**ADDENDUM NO. 12**

REQUEST FOR PROPOSALS  
RFP-HCDA-CIP-2025-01

DESIGN AND CONSTRUCTION SERVICES FOR THE WOMEN'S COMMUNITY  
CORRECTIONAL CENTER – KITCHEN EXPANSION AND RELATED IMPROVEMENTS

**Date Issued: March 16, 2026**

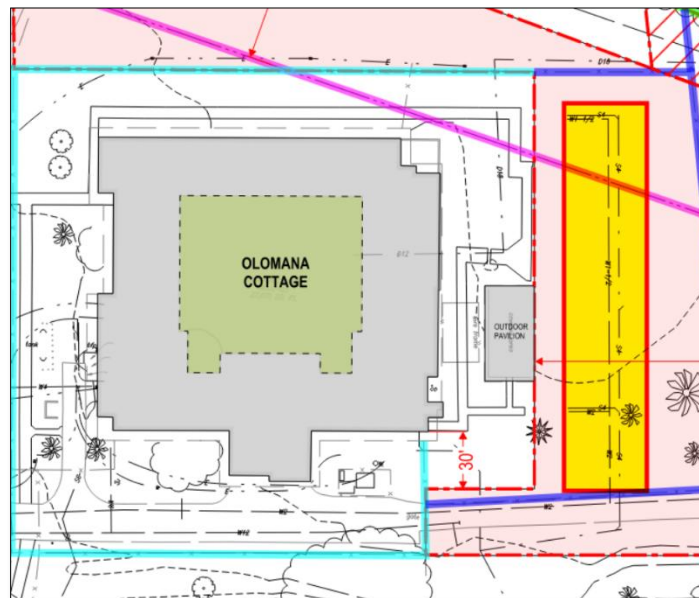
**Question 16:** There are two existing utility lines (4" sewer and 2" water) that run through the project site. However, they are depicted as if they do not connect to any existing buildings. Please confirm if the two existing lines are still in service. See below snapshot for reference.

**Answer 16:** The State recognizes these lines as shown on the available information; however, the active status is unknown. Offerors should include reasonable provisions within their Proposal to investigate and verify the connection, location, extent, and active status of these lines. Any necessary modifications or adjustments to address existing conditions will be handled in accordance with the contract provisions.
